UTTAR PRADESH METRO RAIL CORPORATION LTD.

ADDENDUM-03

Name of Work: Tender AGCC-05: Design and Construction of elevated viaduct and 3 Nos. elevated stations (viz. ISBT, Guru Ka Taal & Sikandara Metro Station) including Civil, Associated Ancillary Structure, Architectural Finishes, Water Supply, Sanitary Installation, Drainage, External Development, Fire Fighting, Fire Detection, E&M works and PEB structures on Balance Section chainage (-) 42.96 m to 3682.941 m of Corridor-1 of Agra Metro at Agra, Uttar Pradesh, India

Reply to Pre-bid queries : Tender AGCC-05

8.6 Switch board bus bars

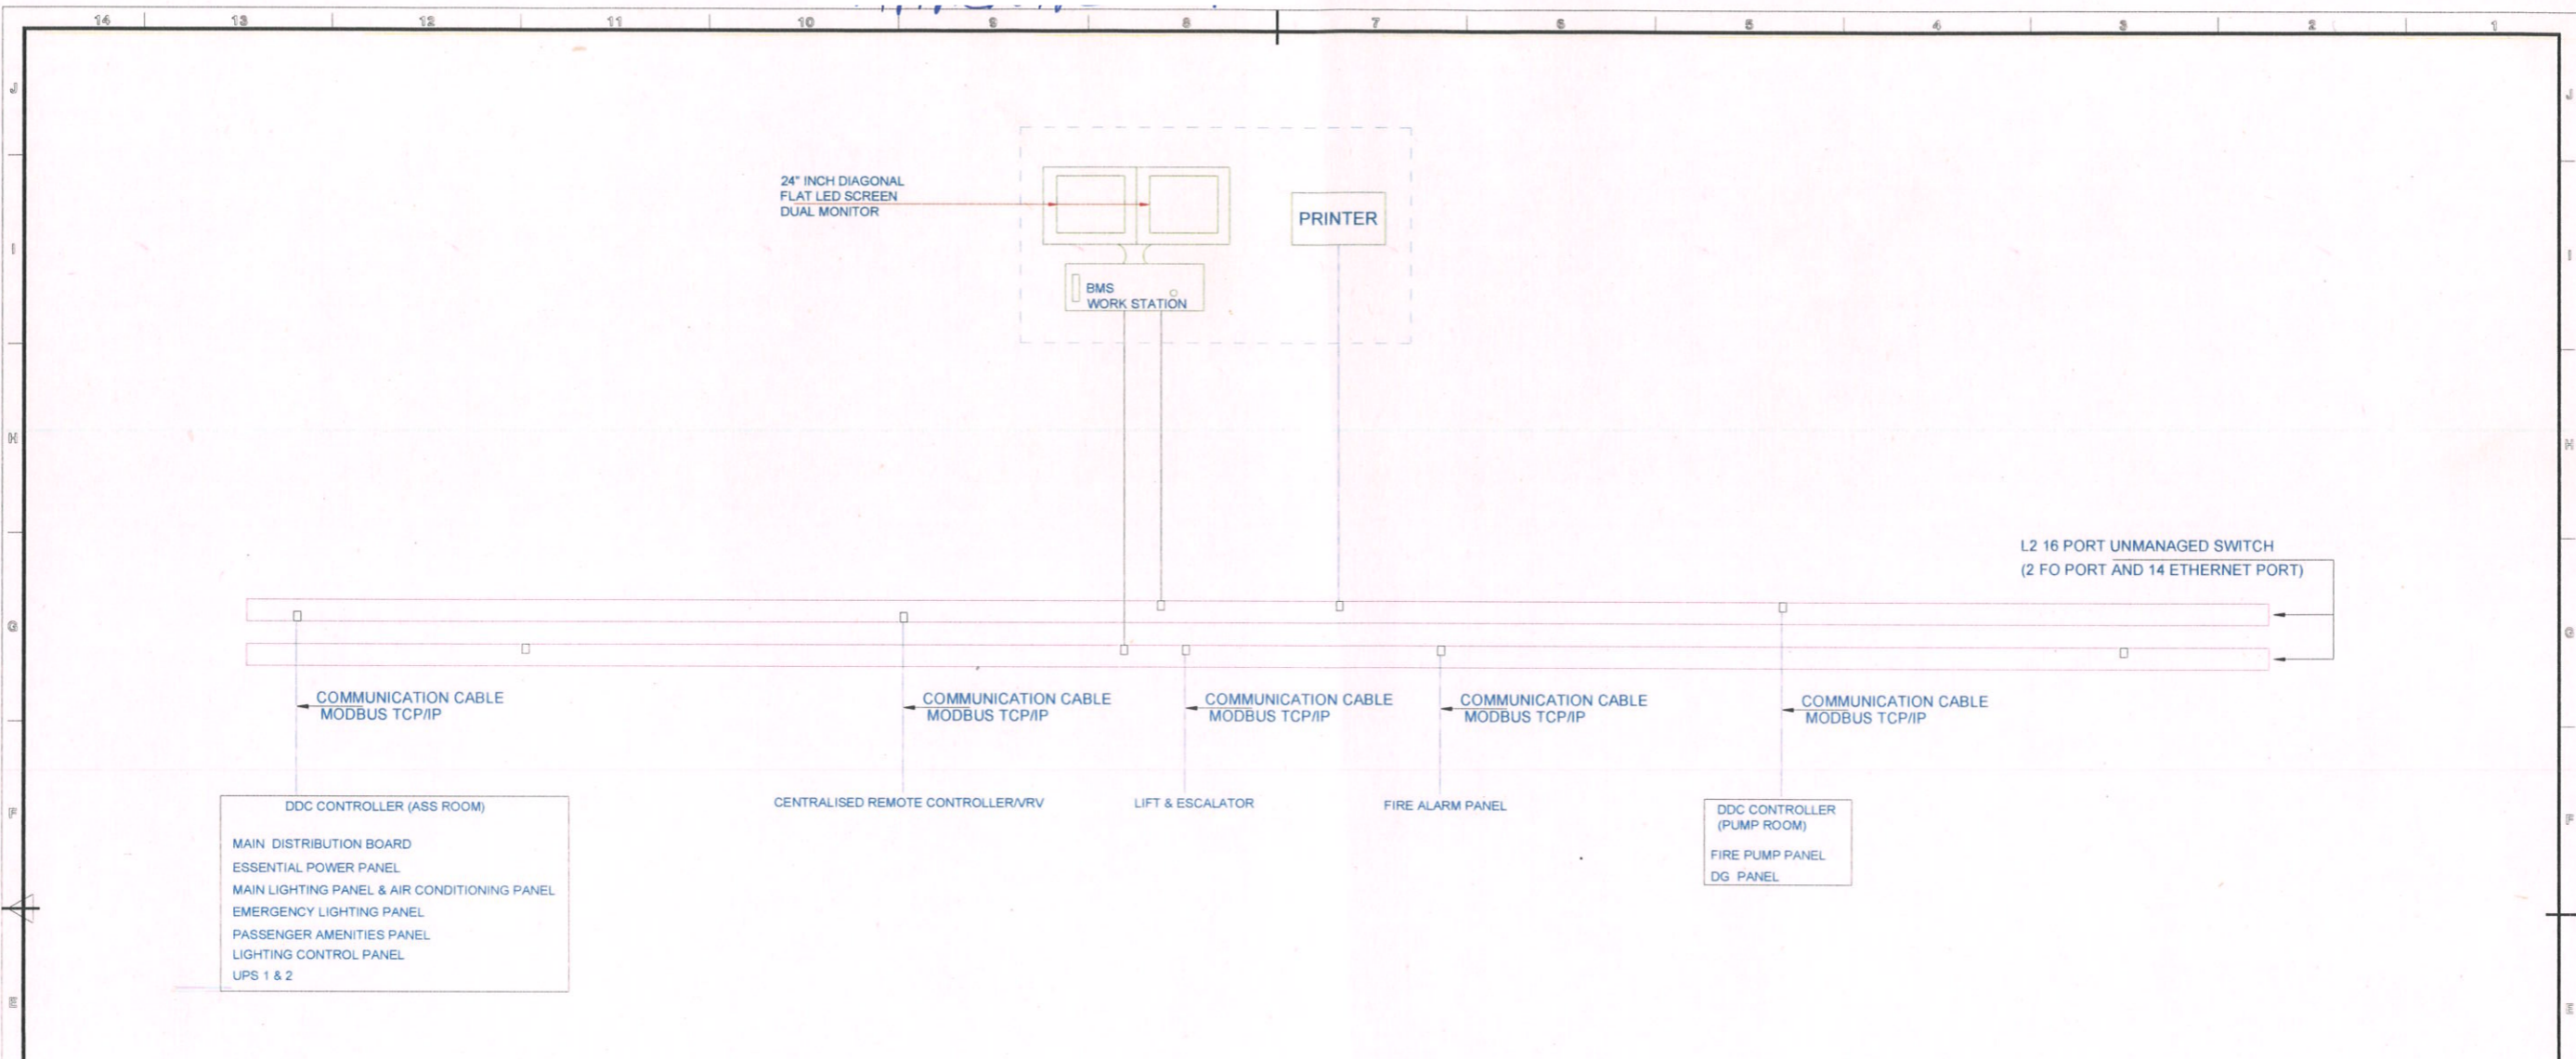
8.6.1 The bus bar and interconnections shall be of ~~electrolytic tinned copper~~ **Aluminium** and of rectangular cross sections suitable for full load current for phase bus bars and full rated current for neutral bus bar as specified in BOQ and shown on drawings and rated for a temperature rise over the ambient temperature specified as per IEC **61439** standards. ~~based on insulated conductor rating and the maximum current density for copper shall be 1.4 amp per mm² for ratings up to 500 Amp and beyond 500 amp maximum current density shall be~~

1.2 amp per mm². Bus bar supporting system shall be suitable to withstand the stresses of a 31 MVA **as per standard to** sustained symmetrical fault level at 415 volts **side** for 1 second or as per schedule of quantities.

S. No.	Reference Clause/ Page No.	Clause in Existing Tender Document	Revised Clause	Revised Clause placed as Annexure/ Pg. No.
1	Vol. 4, OCS , Clause EOO-3.2.3 - Technical Specification: Page 229	All bus bars shall be electrolytic copper with purity of 99.9% and rated for the incoming switch or breaker rating. Current density shall be 1.4 amp/sq. mm up to 500 amp and 1.2 amp/sqmm beyond 500 amp. The Bus Bar temperature rise over ambient shall be as per IS/IEC standards. The calculations for temperature rise should be furnished for approval	All bus bars shall be electrolytic copper with purity of 99.9% <u>Aluminium</u> and rated for the incoming switch or breaker rating. Current density shall be 1.4 amp/sq. mm up to 500 amp and 1.2 amp/sqmm beyond 500 amp. <u>as per IEC or relevant standards</u> The Bus Bar temperature rise over ambient shall be as per IS/IEC standards. The calculations for temperature rise should be furnished for approval.	Please refer Annexure -1 of Addendum-3 Page 229R

WATER SUPPLY SYSTEM - SCHEMATIC DIAGRAM
SCALE: NTS

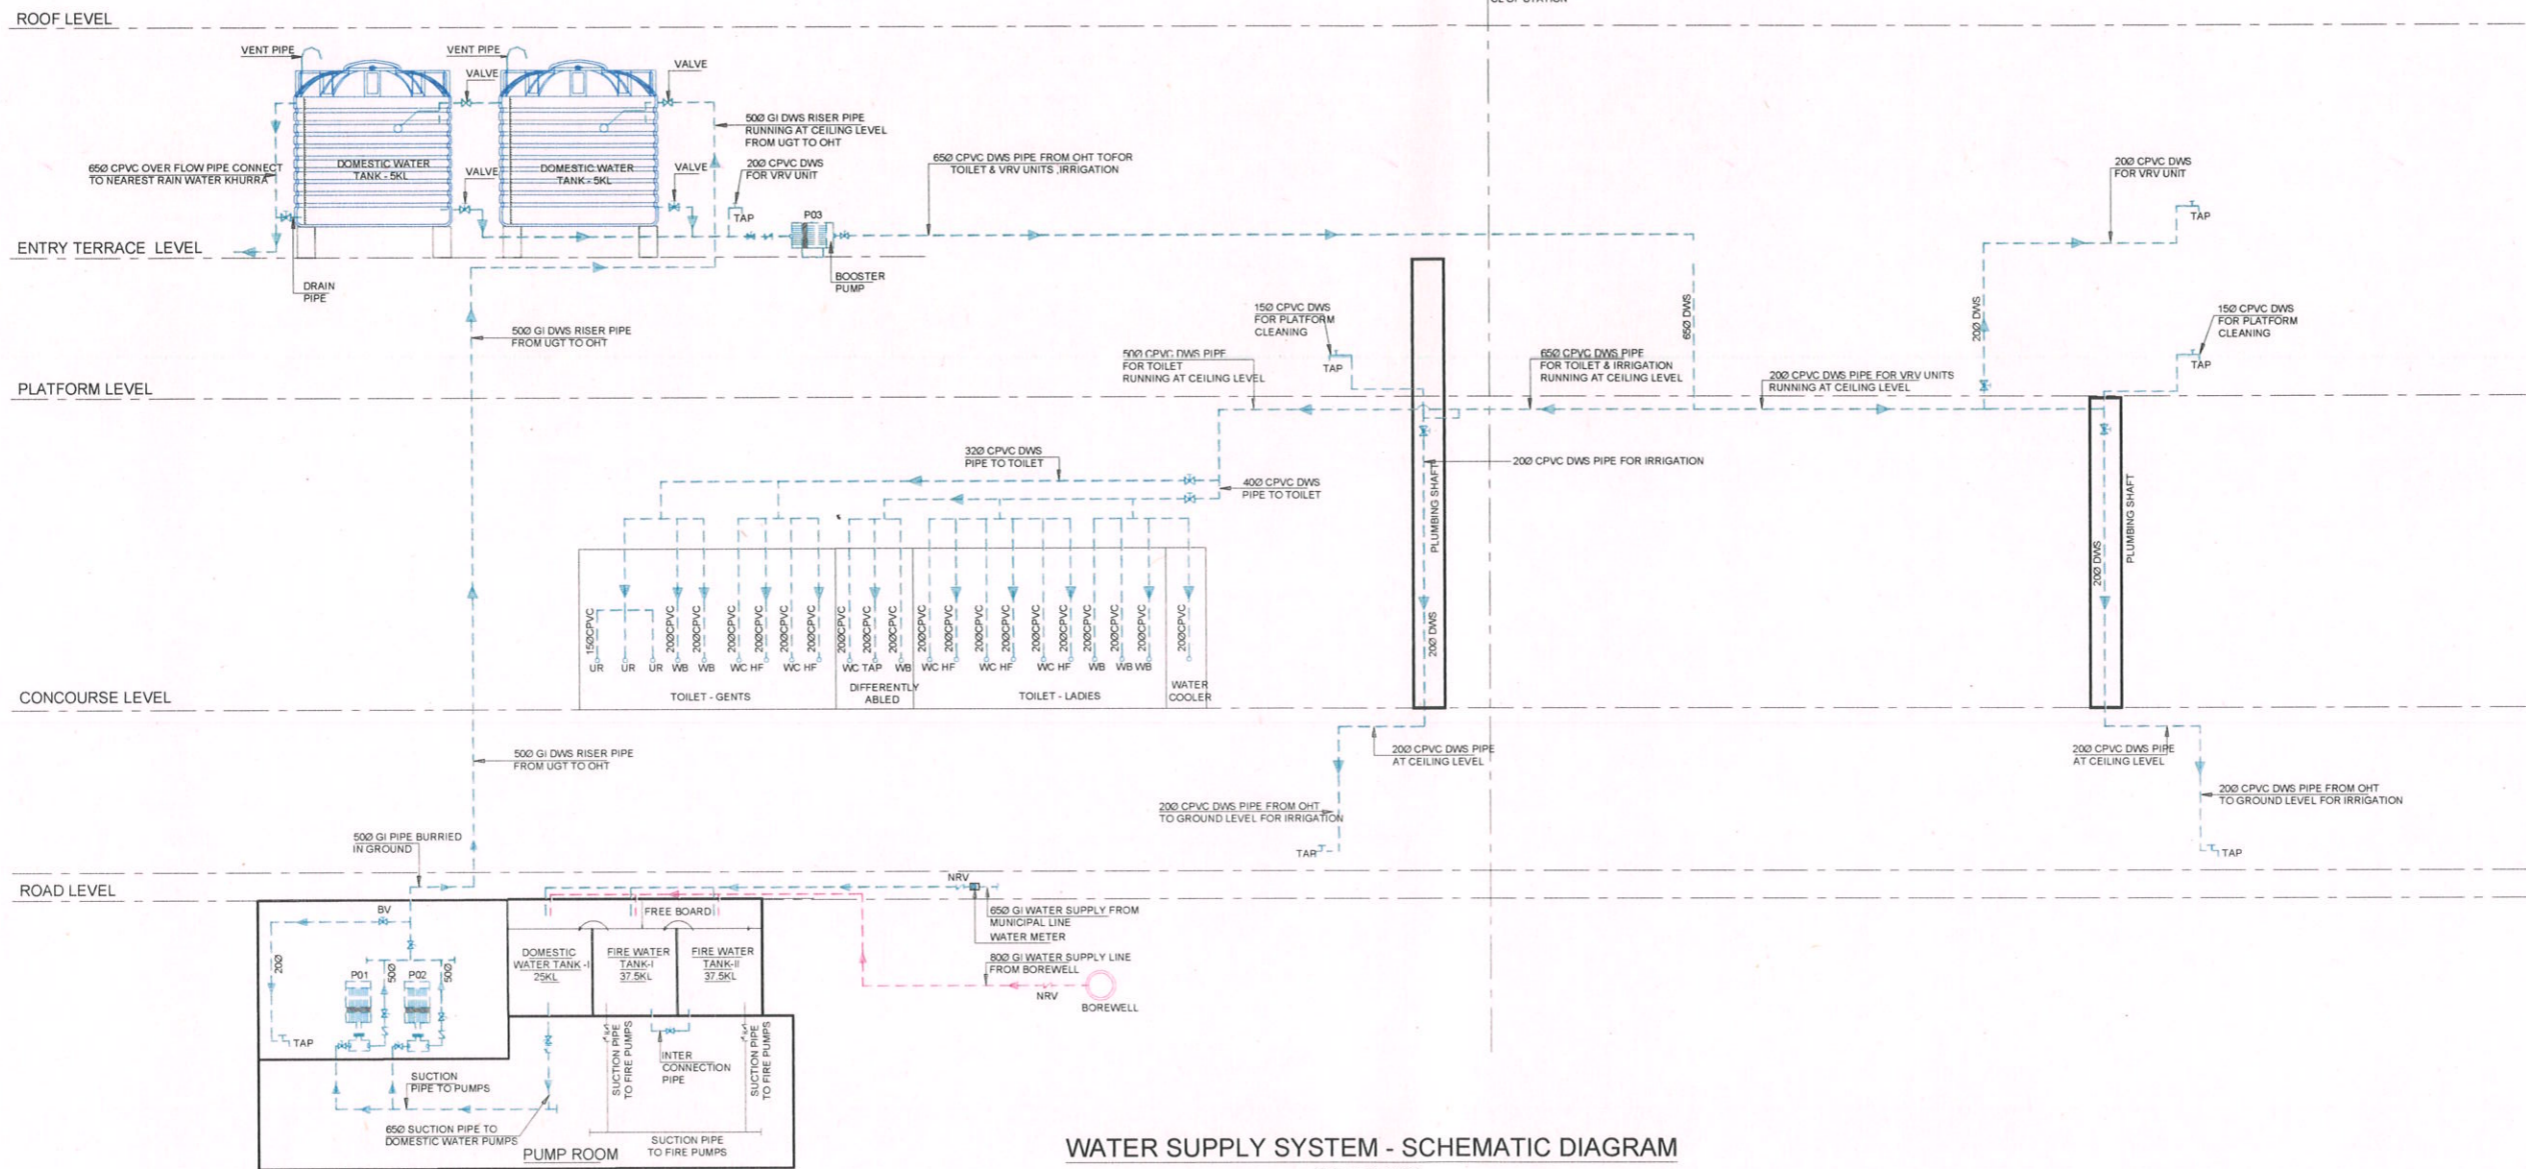
42	DRG No: AGCC05-11718A- TDR-GKT-ME-PLB-61202	Water Supply System- Schematic Diagram	As per schematic drawing (DRG No. AGCC 05-11718A-TDR-GKT- ME-PLB-61202) of water supply water meter is provided but in BOQ of schedule C (C2 NSDR) it is missing. Please clarify.	Please quote as per BOQ.
